An Archaeological Survey of
Well Location Getty Lake Canyon Federal 12-1 and
Associated Access Road, Located on Bug Point,
San Juan County, Utah

RE: Application for Well
Spacing Exception
Getty Oil Company's
Lake Canyon Federal #12-1
700' FNL & 1200' FEL
Section 12-T37S-R25E
San Juan County, Utah

LAKE CANYON FEDERAL OIL & GAS FIELD, UTAH

(other) Amend APD - Correct GR elevation.

Elevations revised 10-8-82

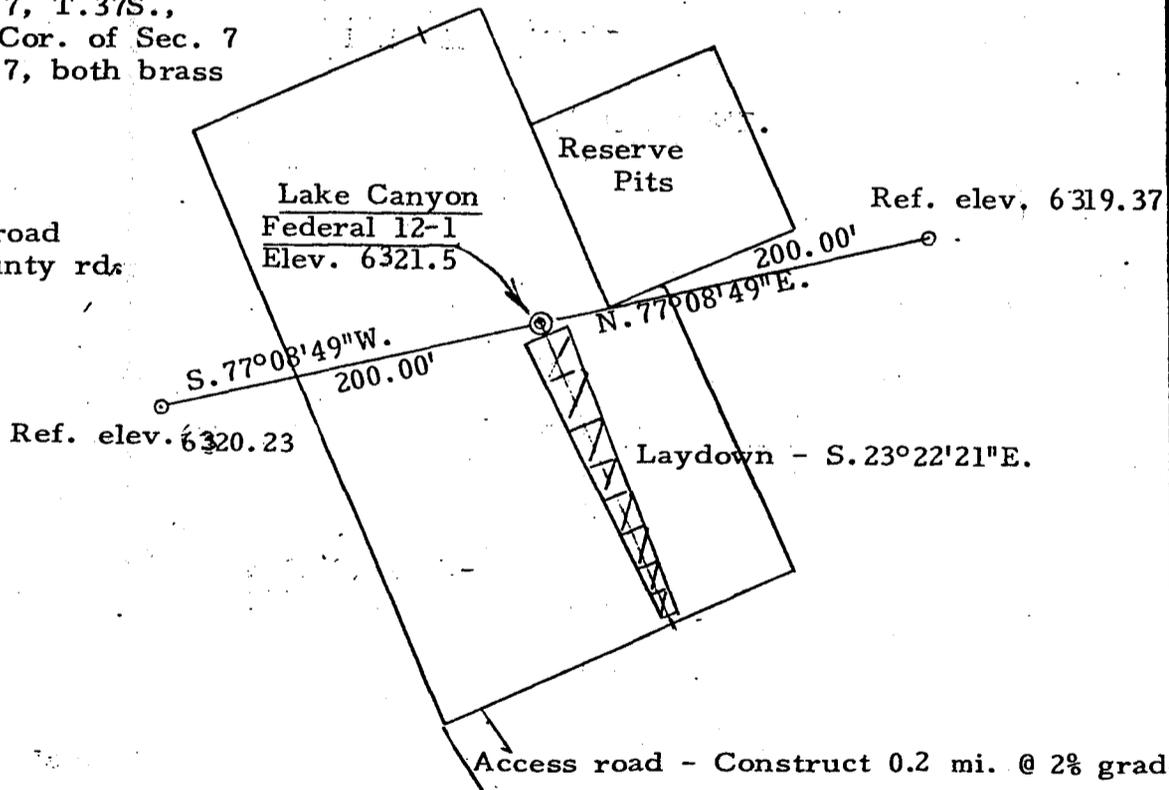
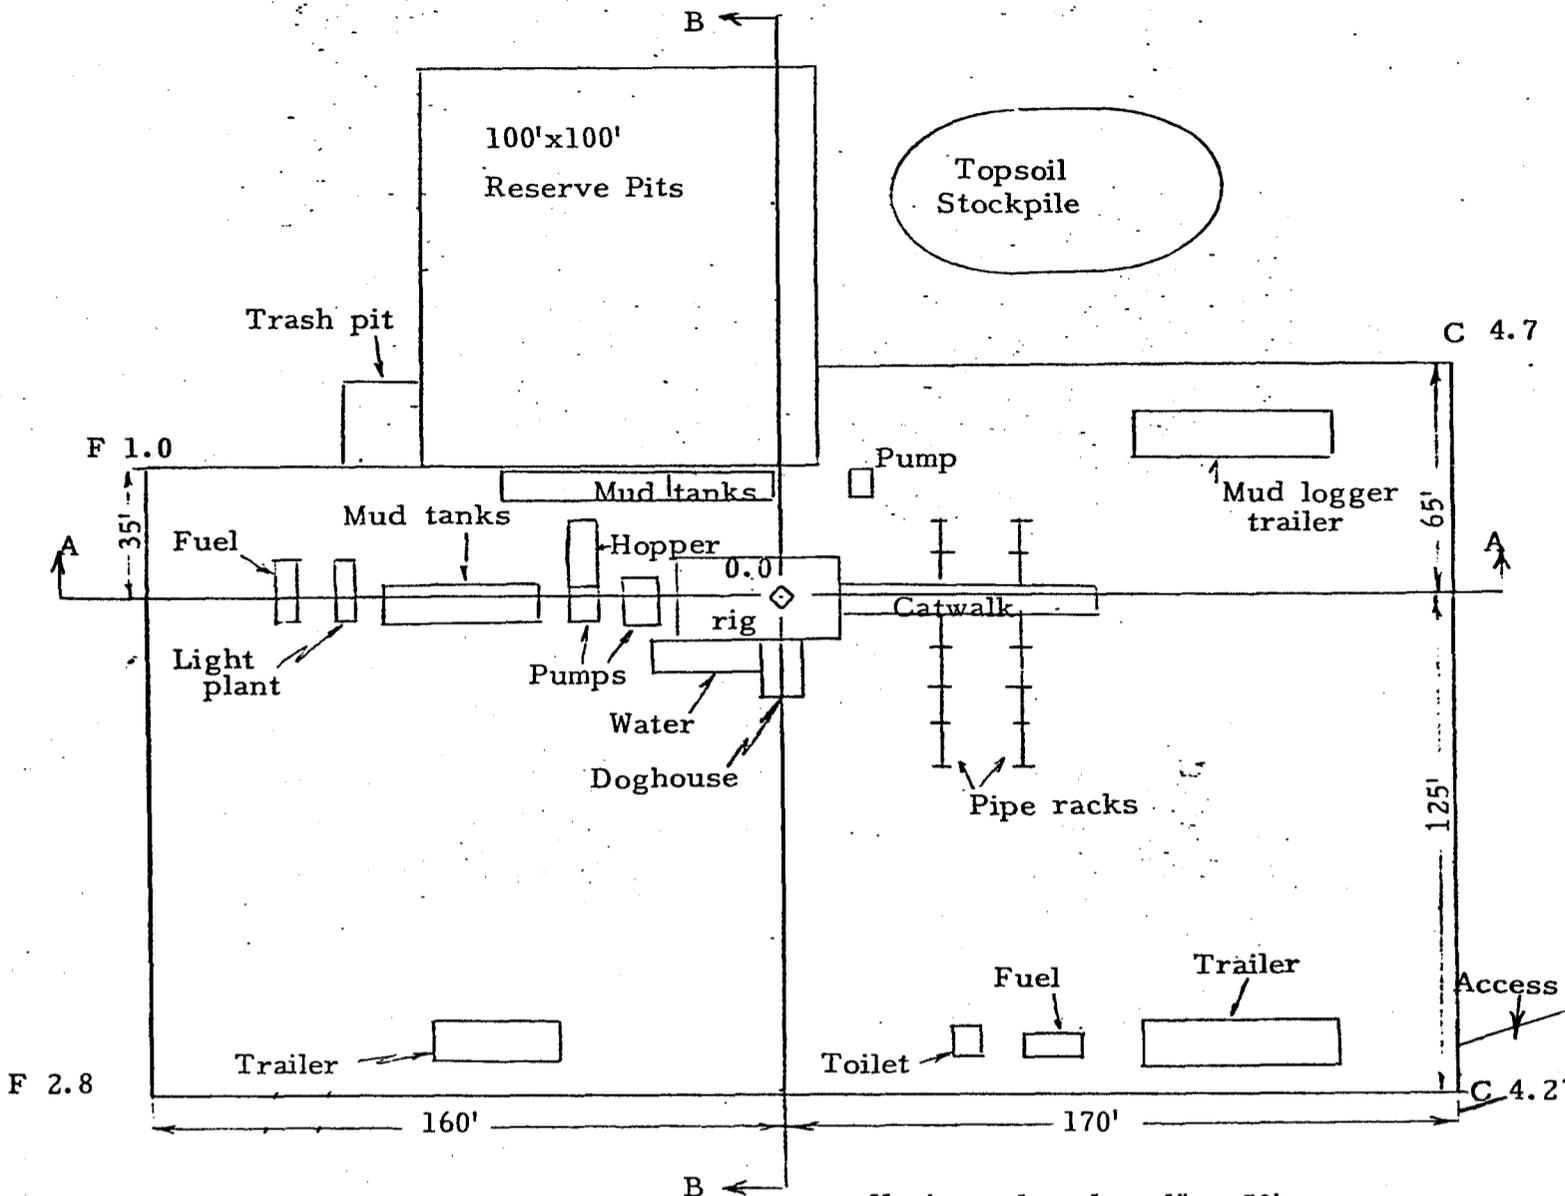
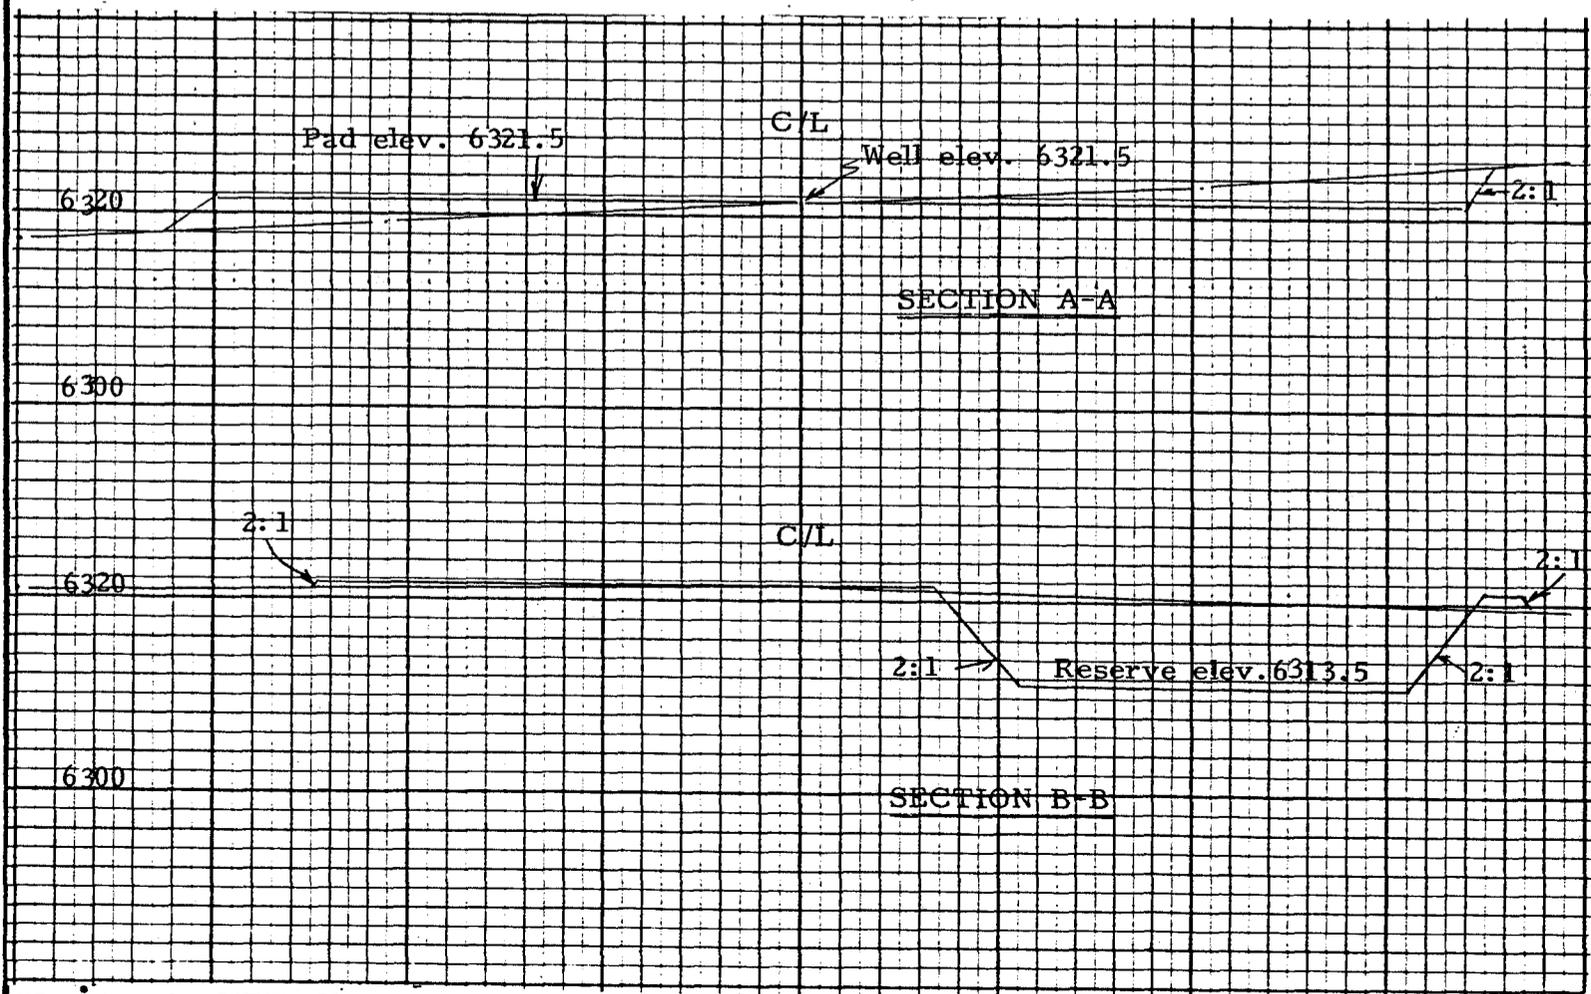
The APD for this well was submitted on 10-4-82 and approved on 10-20-82. The GR elevation on the APD, surveyors plat, and cut and fill diagram was shown as 6222' GR. This elevation is incorrect. Getty Oil Company proposes to correct it to 6322' GR. A revised (dated 10-8-82) surveyors plat and cut and fill diagram are attached.

The APD for this well was submitted on 10-4-82 and approved on 10-20-82. The GR elevation on the APD, surveyors plat, and cut and fill diagram was shown as 6222' GR. This elevation is incorrect. Getty Oil Company proposes to correct it to 6322' GR. A revised (dated 10-8-82) surveyors plat and cut and fill diagram are attached.
